ADDENDUM 1 (AD-1)

Date: December 2, 2013

Owner: Fremont Area Medical Clinic
Project: BP-3 - Interior Fit-Up

Architect: HDR Architecture, Inc.

A1 LEVEL 5 ROOFTOP ENCLOSURE

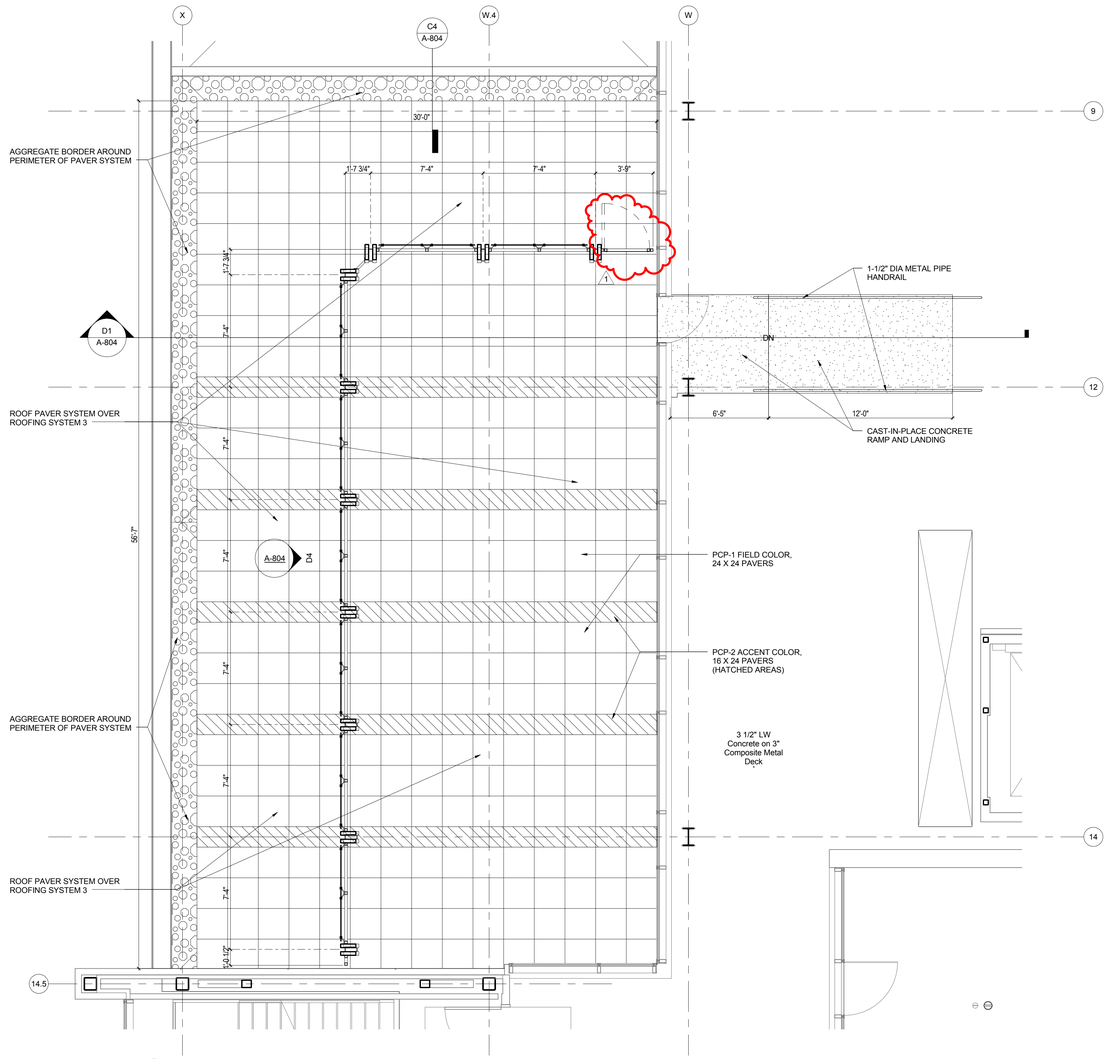
L. Sheet A-801 through A-804 Alternates
1. See plans, elevations, and details for revisions to DPF mounting details at canopy and signage element (Alternate 1B) sheets A-801/A-802/A-803
2. Added gate to roof at roof enclosure on sheet A-804 (Alternate 4)
